UNITED STATES PATENT AND TRADEMARK OFFICE

APPLICATION NO.	FILING DATE	FIRST NAMED INVENTOR	ATTORNEY DOCKET NO.	CONFIRMATION NO.
10/032,454	01/02/2002	Ulrich Watermann	12383-04/ejg	6577

Office Action Summary

DETAILED ACTION

FIGURE 1

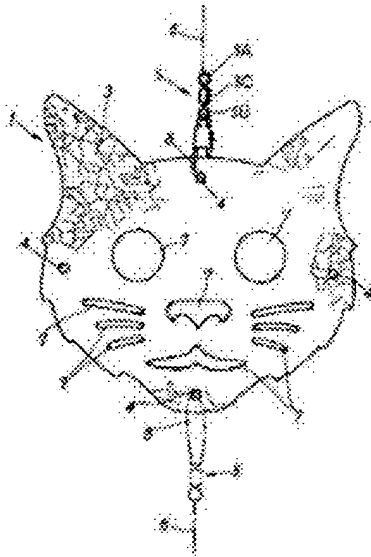
(1) of a cat having at least two holes (4) therethrough, a first line (6) having one end rotatably attached to the hole (4) and a second line (6) having one end rotatably attached to the hole (4).

See Figure 1 below. A third line (10B – See Takeda -Figure 5) is rotatably attached to an end of the first line (6) and to an end of the second line (6) so as to maintain continuity between one end

of the first and second lines (6), respectively, when the first and second lines (6) become unattached to from the holes (4). Though Takeda does not show the third line being connected to the previously mentioned "end" of the lines, it has been held that rearranging parts of an invention involves only routine skill in the art. Takeda fails to teach a silhouette of a bird of prey as a means of scaring off other birds. However, in U.S. Patent 1,428,216, Chase teaches the use of a silhouette (5) of a bird of prey as a scarecrow. Therefore, it would have been obvious to one of ordinary skill in the art at the time of the invention to modify the scaring device disclosed by Takeda to include a silhouette of a bird of prey, as shown by Chase, in an effort to provide a means of scaring off various species of birds.

Regarding **claim 2**, Takeda as modified, teaches a device further including a swivel (5C) connected to the holes (4). One end of the first and second lines (6) is connected to the swivel (5C) so as to permit the silhouette (1) to rotate relative to the lines (6). Takeda fails to show the

ends of the third line directly connected to the swivels. However, it would have been obvious to one having ordinary skill in the art to relocate the third line (10B) since it has been held that rearranging parts of an invention involves only routine skill in the art. See Figure 1 above.

In regards to **claim 8**, Takeda as modified teaches a device wherein the panel freely rotates about the first and second lines (6). See Figure 1 above.
